**RE: Happy Avenue ROW– Comparison of Existing Conditions with 1998 Wetlands Crossing Plan  
CMA #591-146**

In accordance with our task assignment #591.146, we have prepared this letter to summarize our review of existing conditions at the Happy Avenue driveway and proposed Right-of-Way with respect to the March 1998 Wetland Crossing Plan approved by the Kittery Planning Board in July 1999.

*Comparison of Existing Driveway with 1998 Wetlands Crossing Plan*

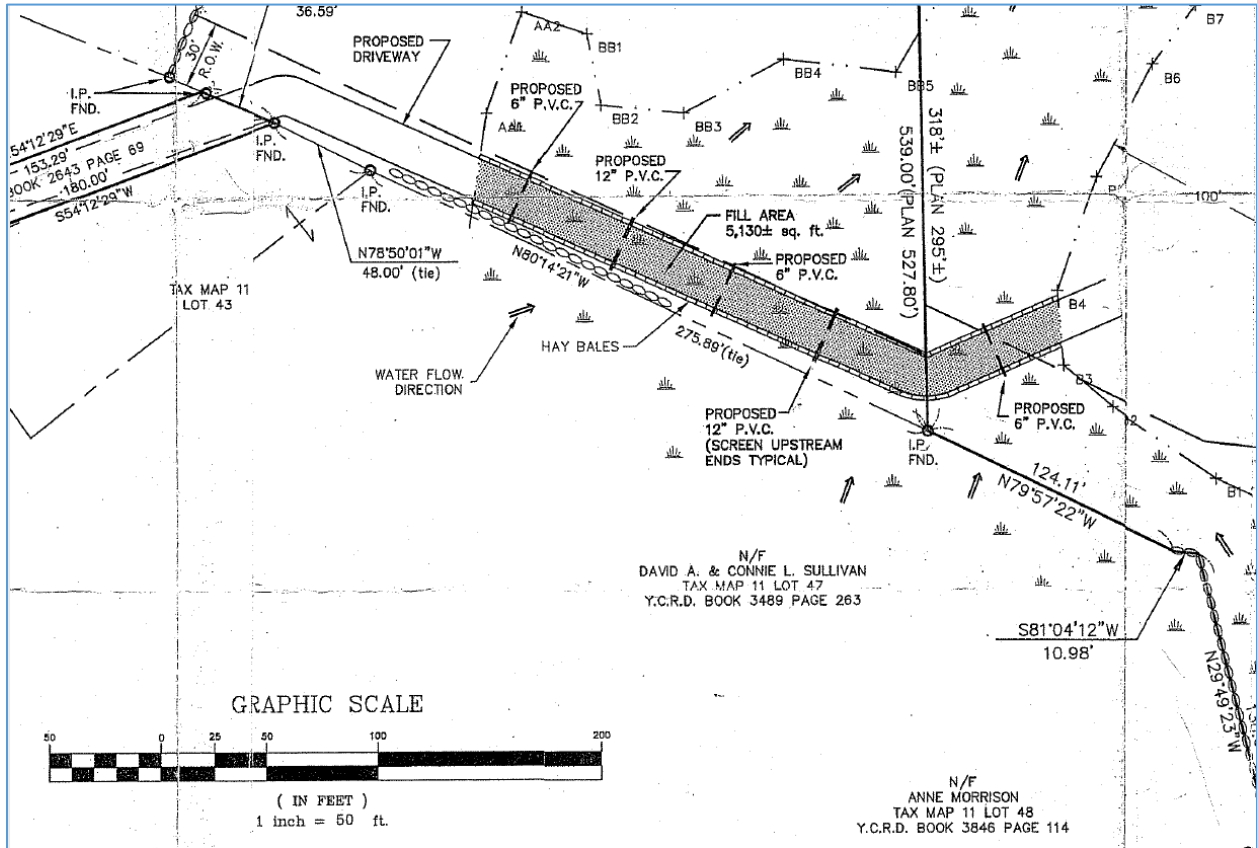
The actual fill coincides with the approved 1998 Wetland Crossing Plan for most of the alignment. However, the driveway at the eastern limit of the alignment diverges and extends easterly/southeasterly into the property and does not follow the permitted northeasterly angle. Approximately 80-100 feet of wetlands were filled outside of the approved plan. It is noted that a similar length of approved for wetlands filling in the 1998 plan remains wetlands and was not filled. (*See figure with comparison, below.*)

Segment of the 1998 Wetlands Crossing Plan

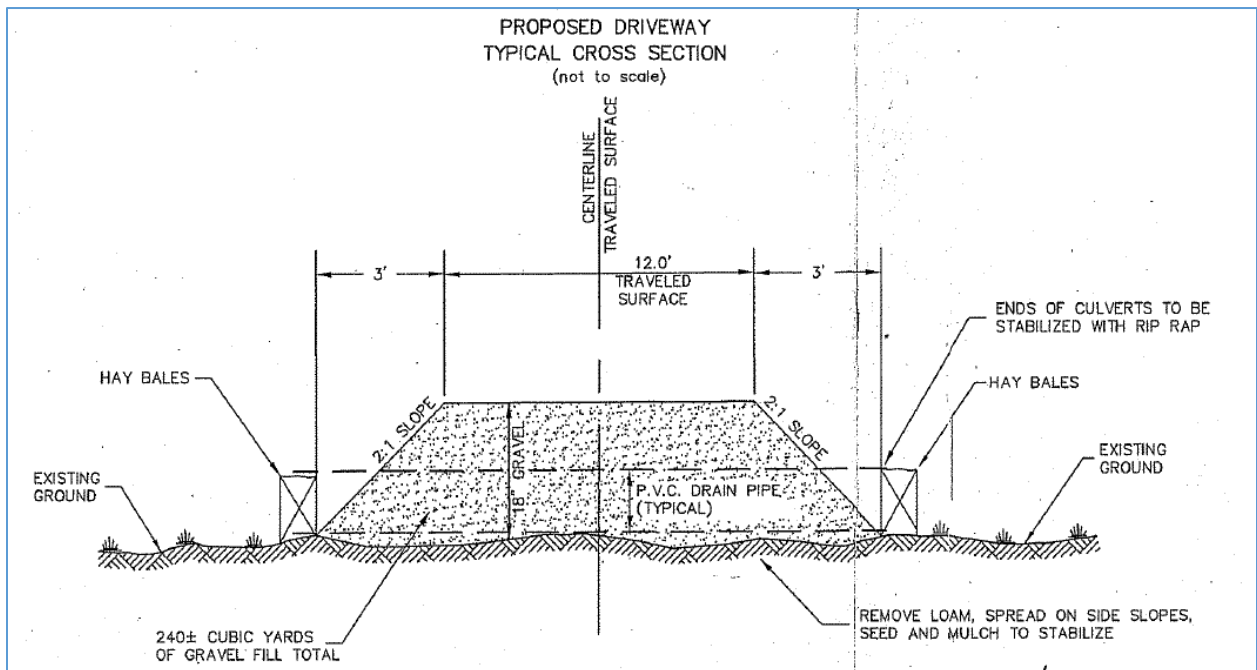
The 1998 wetland crossing plan depicts a 12-foot-wide driveway, with side slopes, constructed over approximately 250 feet of wetlands to access Tax Map 11, Lot 29. A residence has since been constructed on the lot and has been accessed off Happy Avenue for many years. There were four proposed pipes crossing the wetlands fill, to equalize marsh elevations and transmit flow. The alignment was straight and parallel to the property line until a property corner (since eliminated), where the fill was designed to angle to the northeast, and into the property. (*See segments from the 1998 plan.*)

Roadway Cross-Section from the 1998 Wetlands Crossing Plan

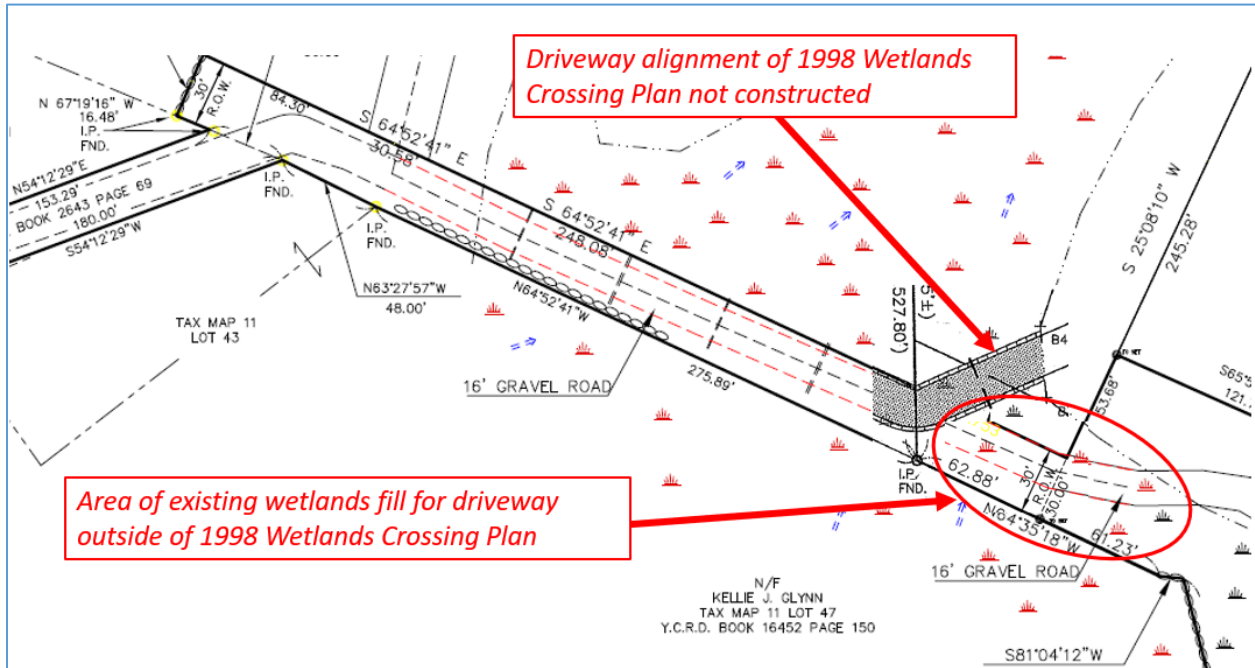
With the exception of the alignment issue described above, construction of the driveway was consistent with the details included on the 1998 Wetland Crossing Plan:

- Driveway with was 12 feet wide (or very close);
- Each of the pipe crossings are present, with the diameters indicated, with remnants of erosion control evident;
- The thickness of the fill and side-slopes were consistent with the plan;
- At one if the 12-inch pipes, flow was evident. It was in a southerly direction. The plan indicated flow in a northerly direction. (This observation is noted but is a deviation from the design that was constructed.)
- It is noted that 21 Happy Avenue appears to be accessed only from those driveways, with access to Roseberry Lane blocked off.
